Planning and Zoning Commission
December 7, 2021
Agenda
Meeting Held Electronically due to COVID-19
5:30 P.M.

TO: Planning and Zoning Commission
FROM: Evann Martin, Assistant Planner
DATE: December 7, 2021
RE: Freddy's and Panera – Preliminary Plat

RE: Freddy's/Panera Site Plan

TO: Planning and Zoning Commission
FROM: Evann Martin, Assistant Planner
DATE: December 7, 2021
RE: Freddy's and Panera – Site Plan

LANDSCAPE PLAN

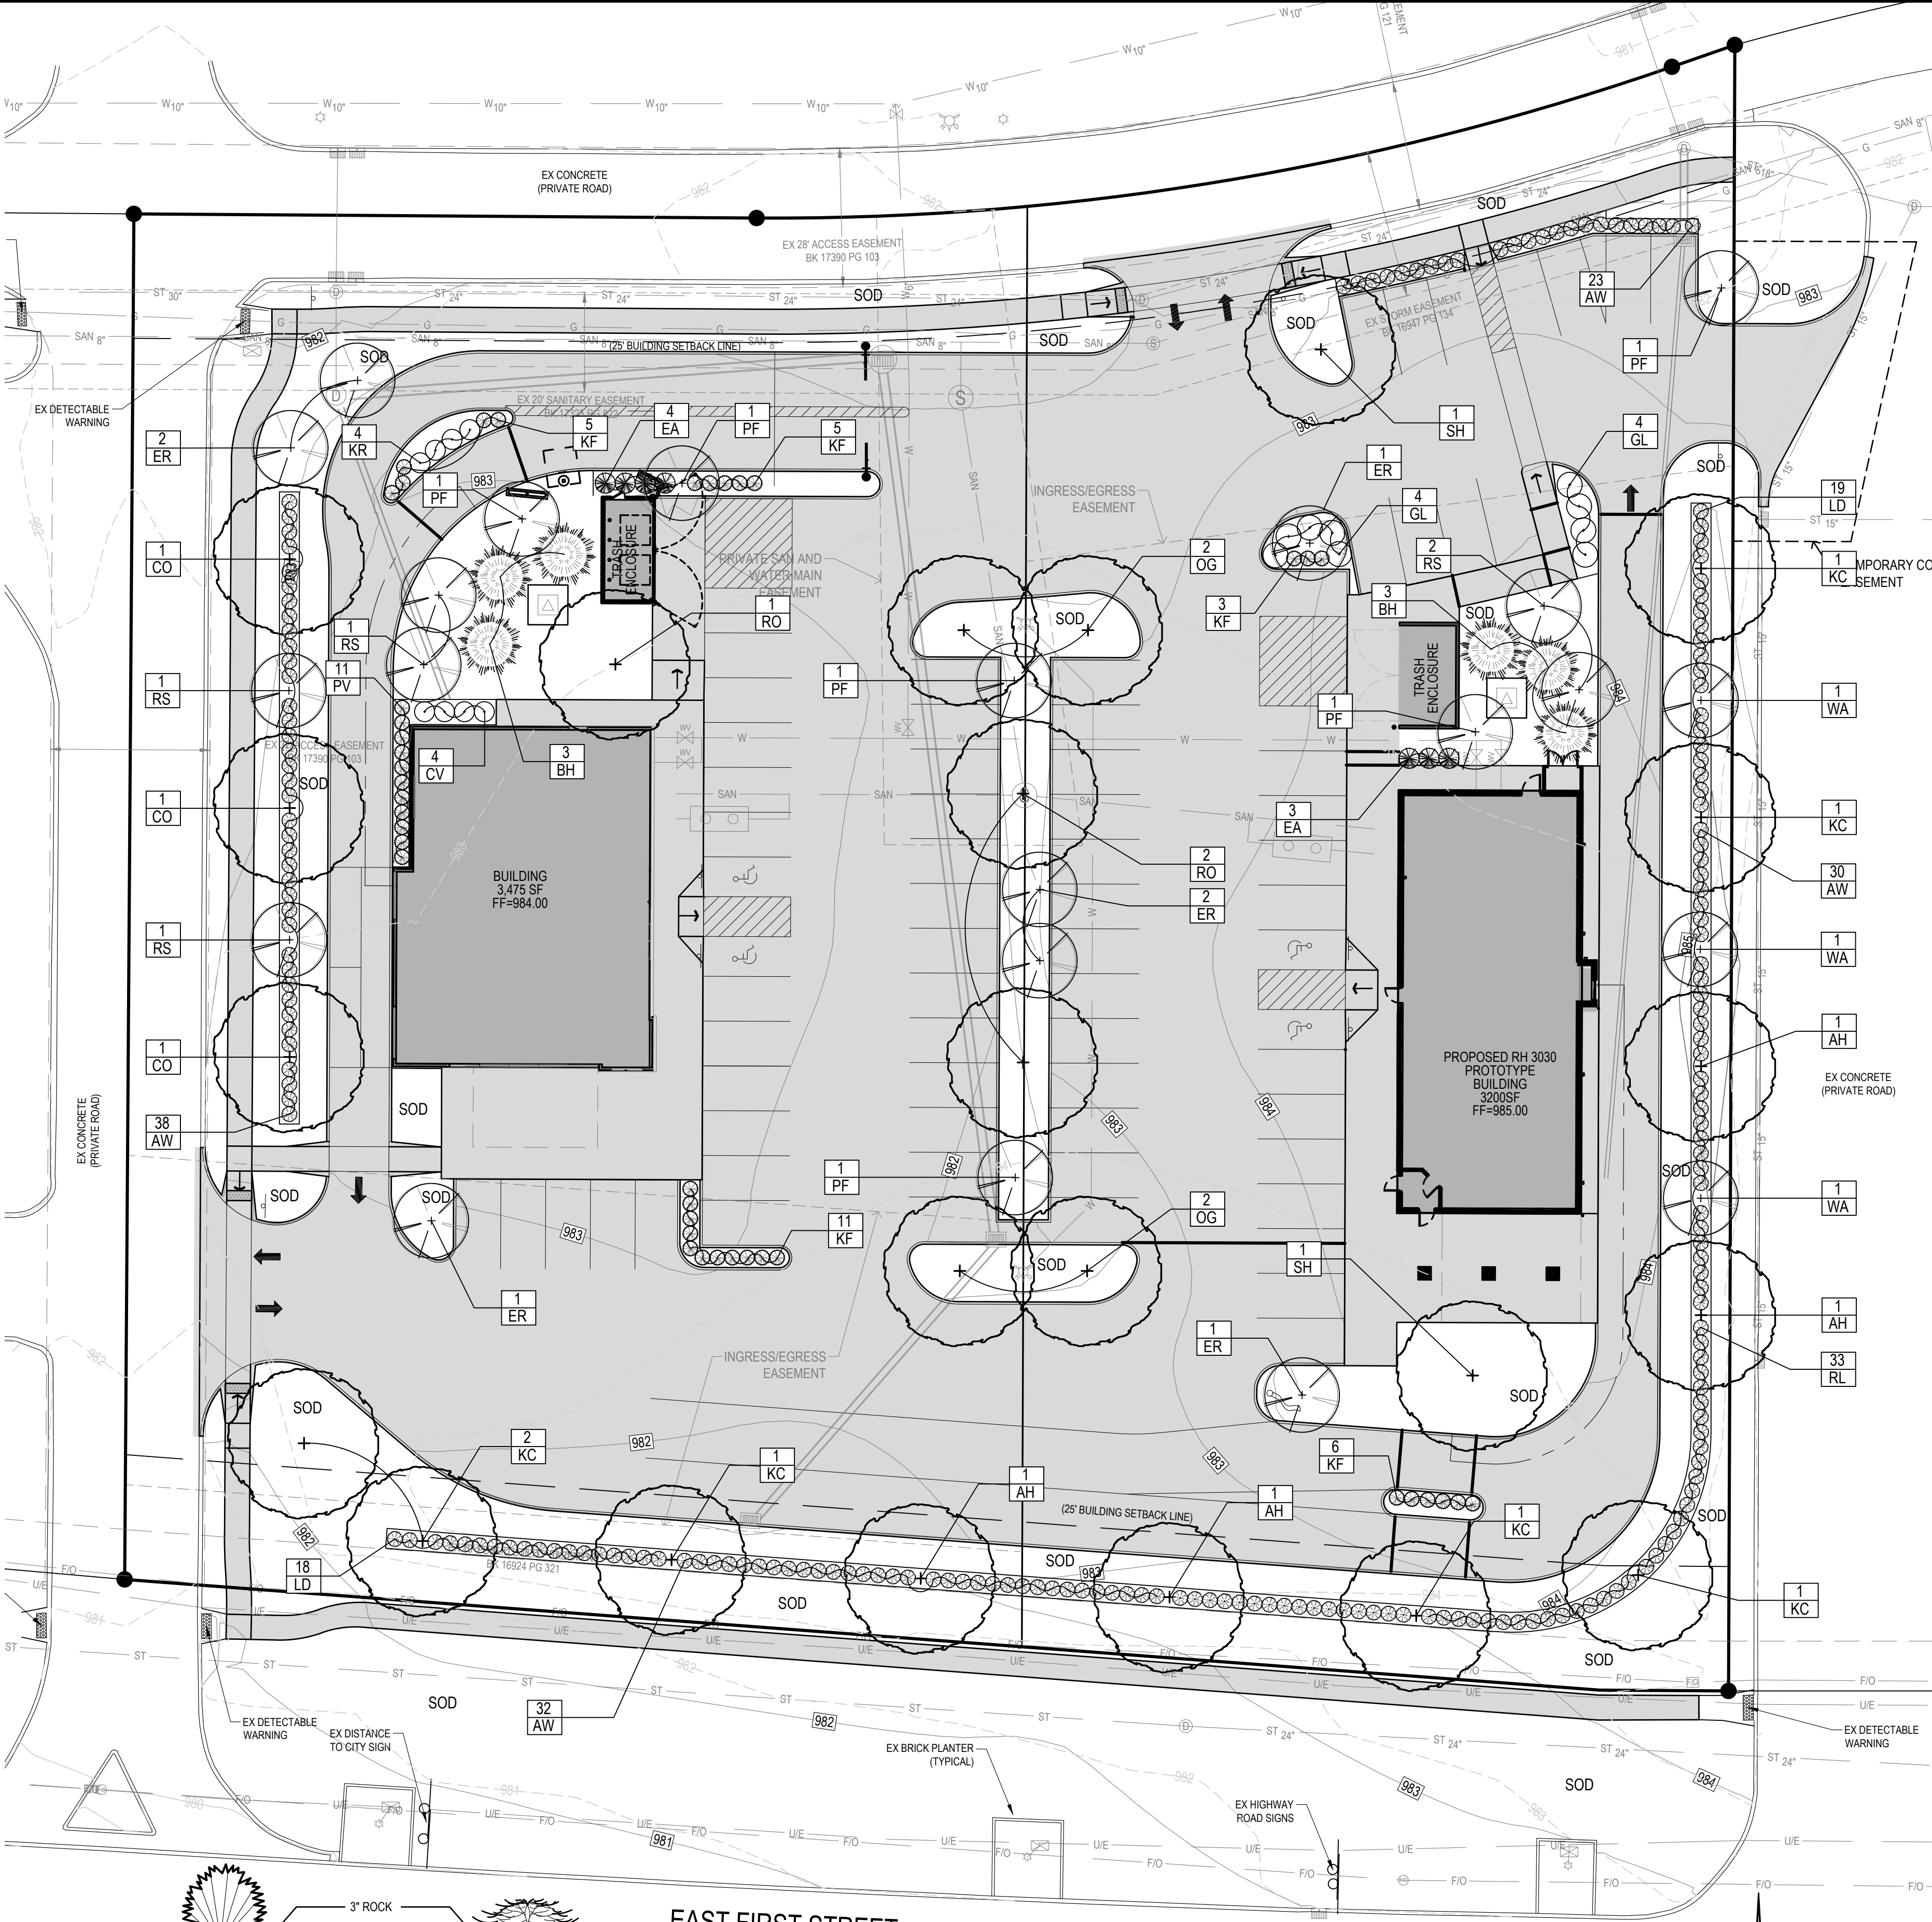
- ~~1. Update required open space square footage. A minimum of 20% open space is required for each lot.~~
- ~~2. Update required open space plantings per the 20% open space requirement.~~
- ~~3. Provide shrub calculations per 165A.16.3 and 165A.16.9.~~
- ~~4. Provide ROW landscape buffer planting calculations.~~
- ~~5. Please revise Note 13 to require City authorization for landscape planting changes.~~

- ~~6. Please provide shrubs along the north parking spaces to shield headlights from the street.~~

LOT 1 (PANERA)	
SITE AREA	50,500 SF
OPEN SPACE PROVIDED	14,453 SF
OPEN SPACE REQUIRED (20%)	10,100 SF

LOT 2 (FREDDY'S)	
SITE AREA	43,593 SF
OPEN SPACE PROVIDED	12,088 SF
OPEN SPACE REQUIRED (20%)	8,720 SF

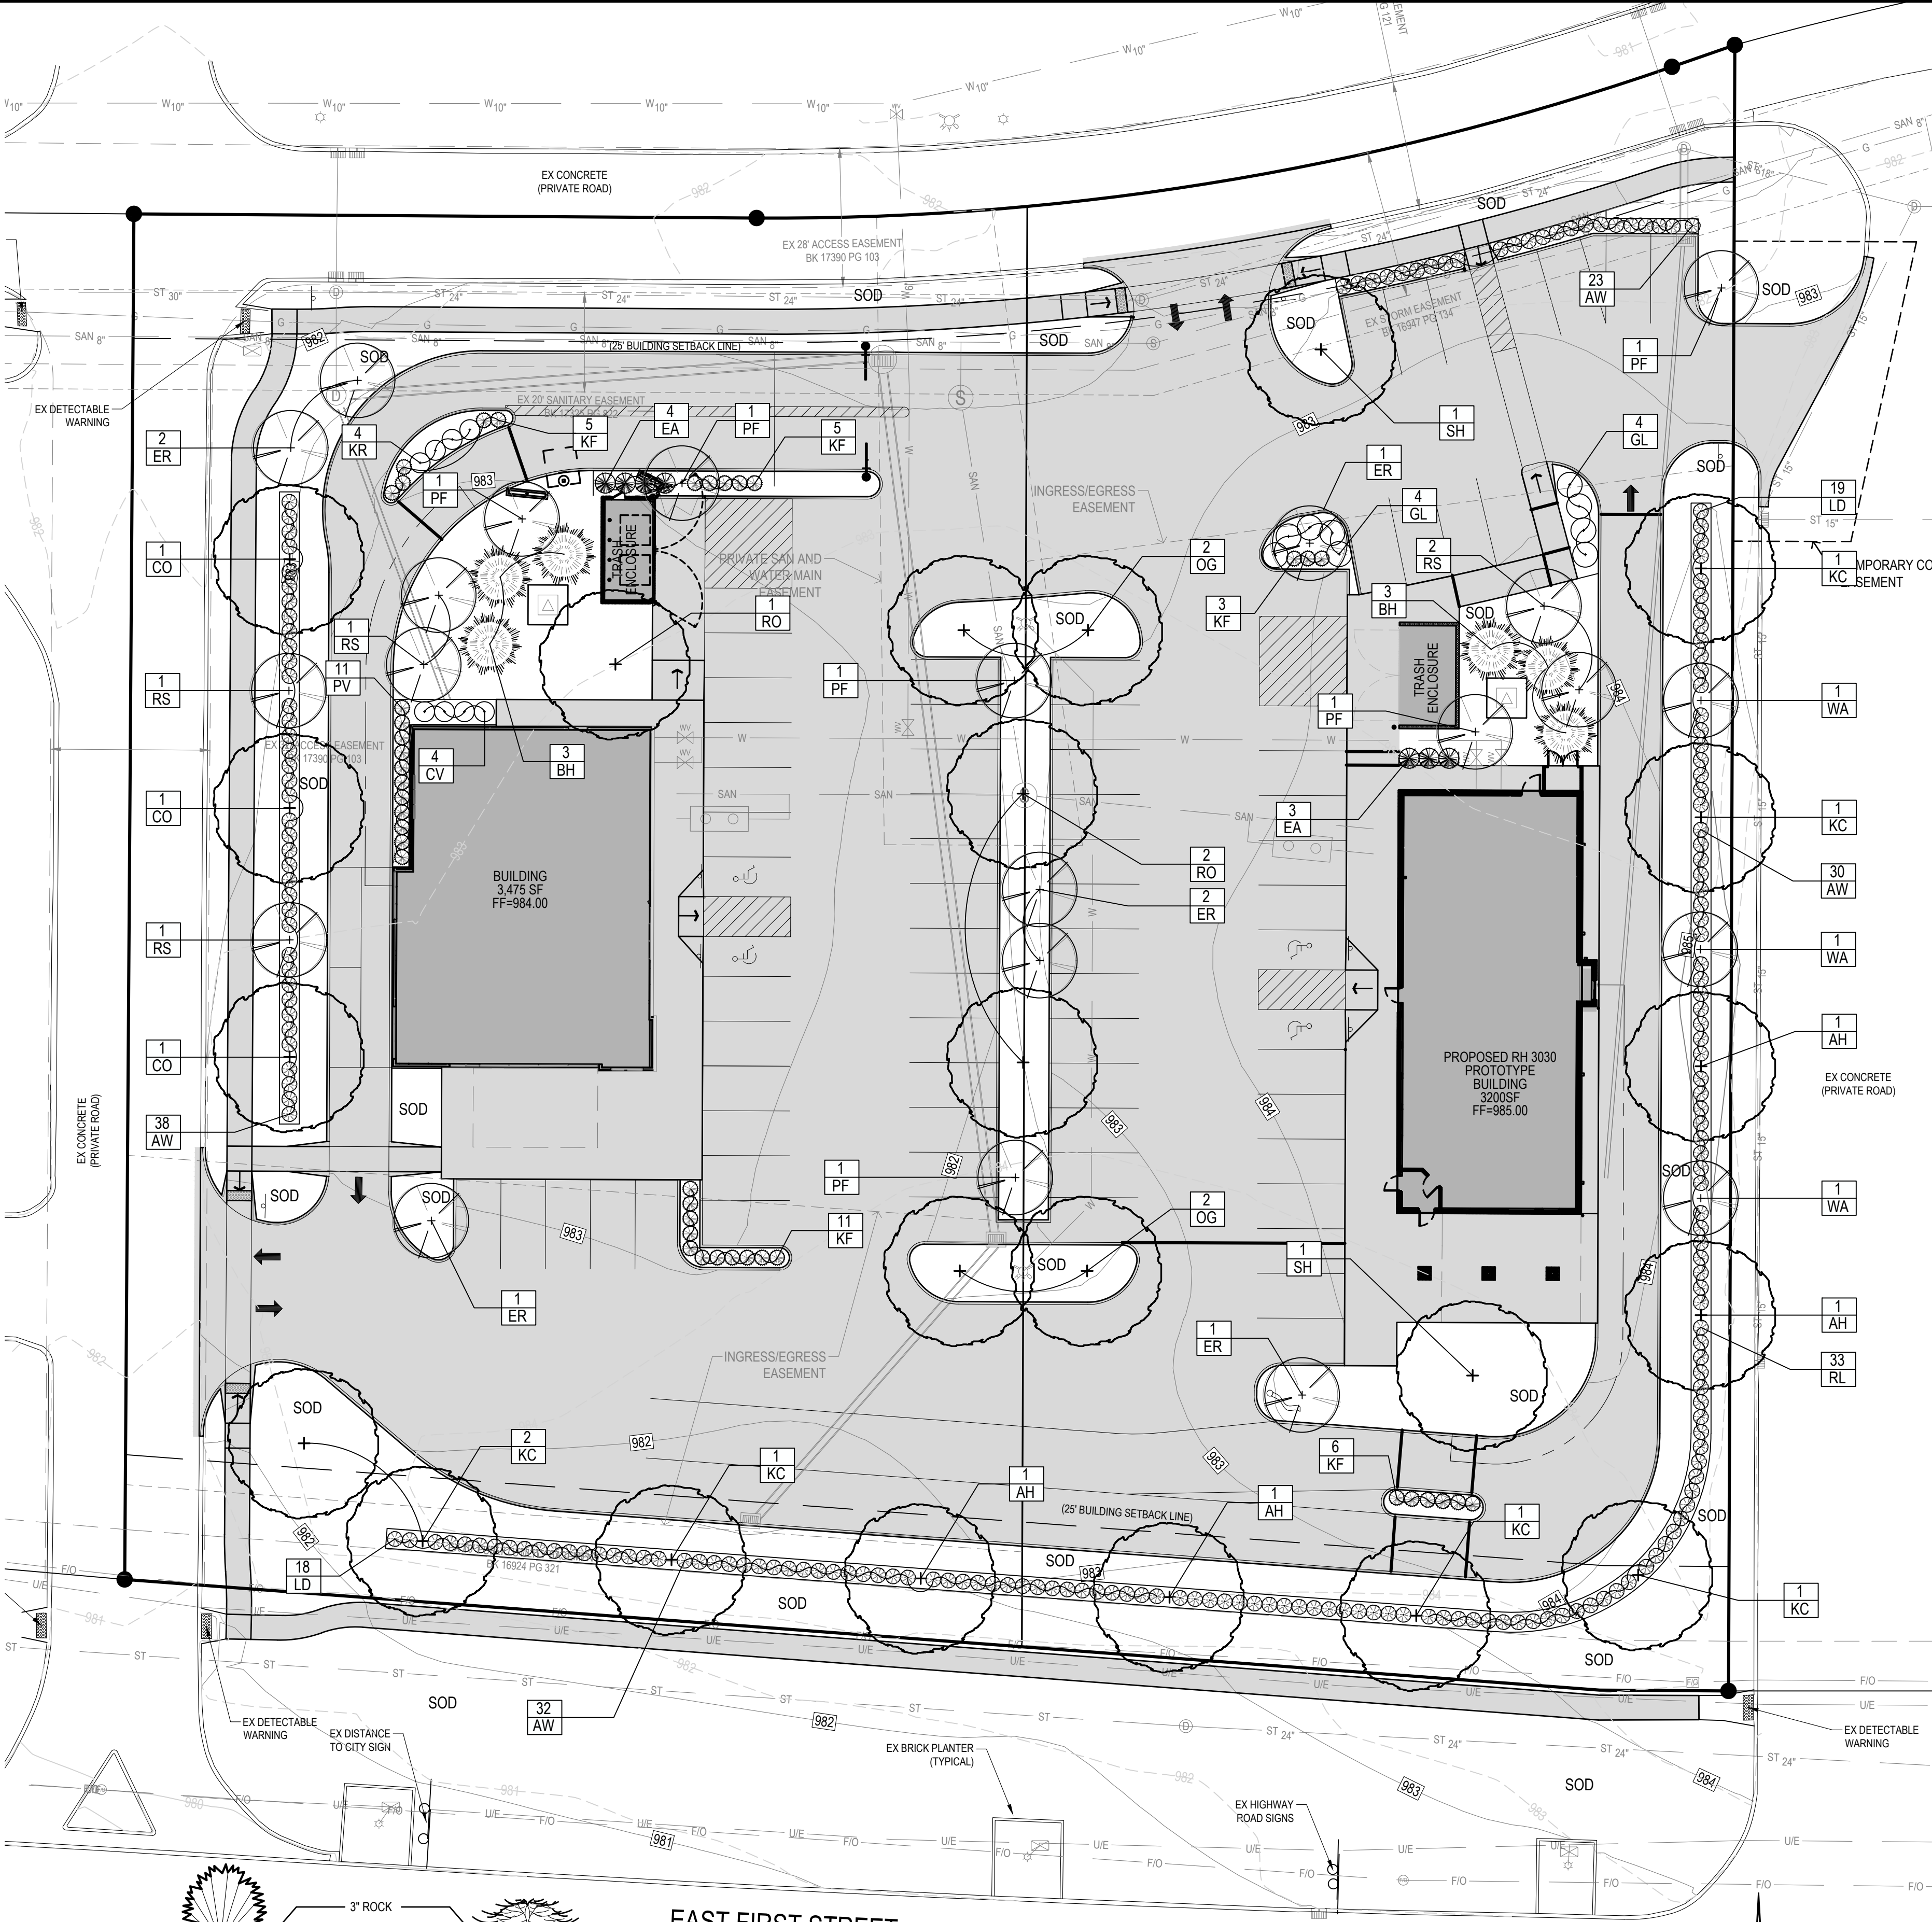
- ~~1. Update required open space square footage. A minimum of 20% open space is required for each lot.~~
- ~~2. Update required open space plantings per the 20% open space requirement.~~
- ~~3. Provide shrub calculations per 165A.16.3 and 165A.16.9.~~
- ~~4. Provide ROW landscape buffer planting calculations.~~
- ~~5. Please revise Note 13 to require City authorization for landscape planting changes.~~

- ~~6. Please provide shrubs along the north parking spaces to shield headlights from the street.~~

LOT 1 (PANERA)	
SITE AREA	50,500 SF
OPEN SPACE PROVIDED	14,453 SF
OPEN SPACE REQUIRED (20%)	10,100 SF

LOT 2 (FREDDY'S)	
SITE AREA	43,593 SF
OPEN SPACE PROVIDED	12,088 SF
OPEN SPACE REQUIRED (20%)	8,720 SF

2 EXTERIOR ELEVATION - SOUTH
SCALE: 1/4" = 1'-0"

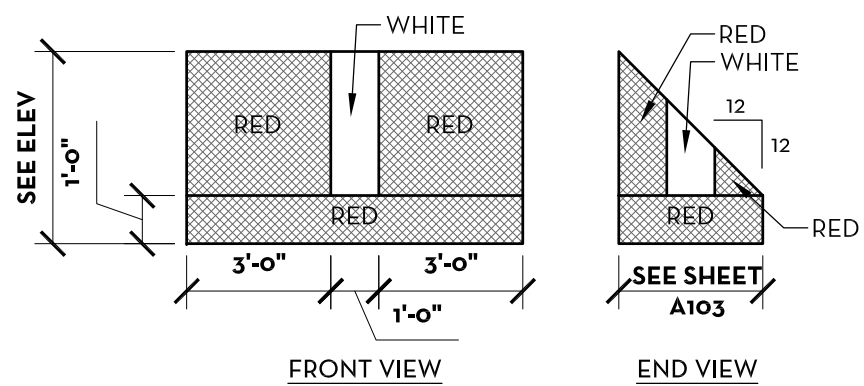
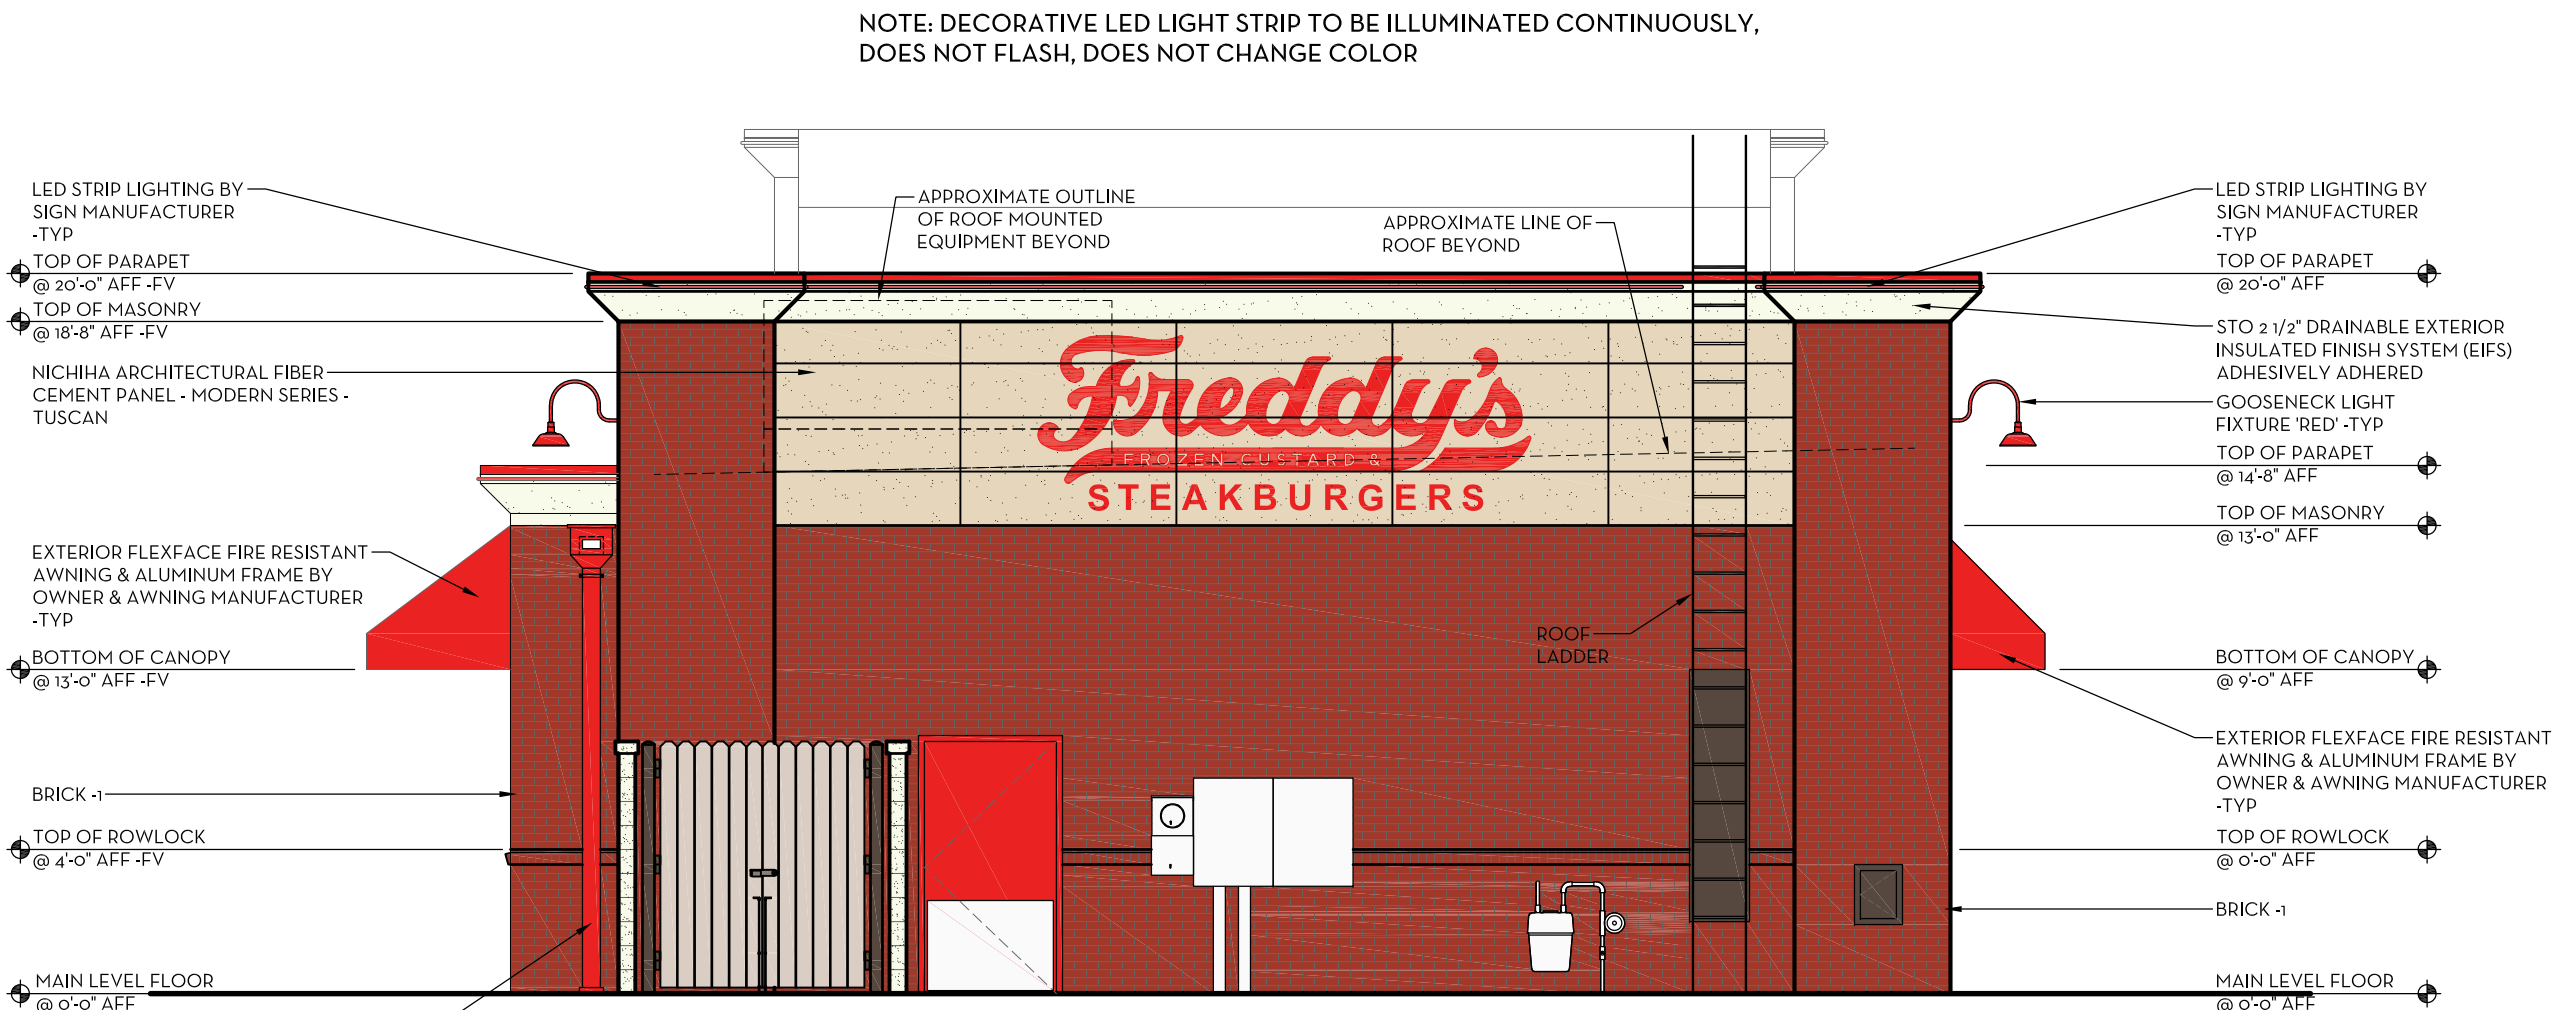
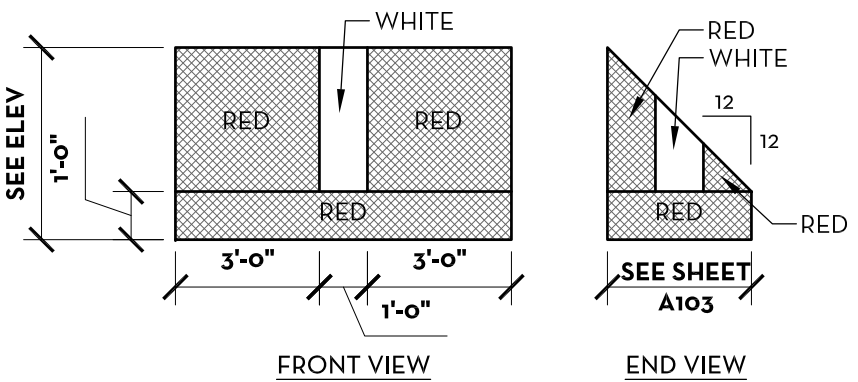
- ~~1. Provide building material percentages (excluding windows and doors). A minimum of 75% of each façade is required to be primary material. EIFs is not considered primary material. Please see Zone 1 architecture requirements in Section 165A.24 for reference.~~

- ~~2. Provide glazing percentages. The south façade is required to have 20% glazing. Please revise.~~
- ~~3. Provide list of 5 treatments demonstrated on the elevations per 165A.24 (page 15).~~

WEST FACADE WALL AREA EXCLUDING
WINDOWS AND DOORS: 1508 SF
BRICK: 978 SF (65%)
FIBER CEMENT: 408 SF (27%)
EIFS: 122 SF (8%)

SOUTH FACADE WALL AREA EXCLUDING
WINDOWS AND DOORS: 646 SF
BRICK: 314 SF (49%)
FIBER CEMENT: 279 SF (42%)
EIFS: 60 SF (9%)

SOUTH FACADE WINDOWS AND DOORS: 255 SF

EXTERIOR FACADE CALCULATIONS
EAST FACADE WALL AREA EXCLUDING
WINDOWS AND DOORS: 1,657 SF
BRICK: 1,091 SF (66%)
FIBER CEMENT: 427 SF (26%)
EFS: 139 SF (8%)

EXTERIOR FACADE CALCULATIONS
NORTH FACADE WALL AREA EXCLUDING
WINDOWS AND DOORS: 757 SF
BRICK: 540 SF (71%)
FIBER CEMENT: 160 SF (21%)
EFS: 57 SF (8%)
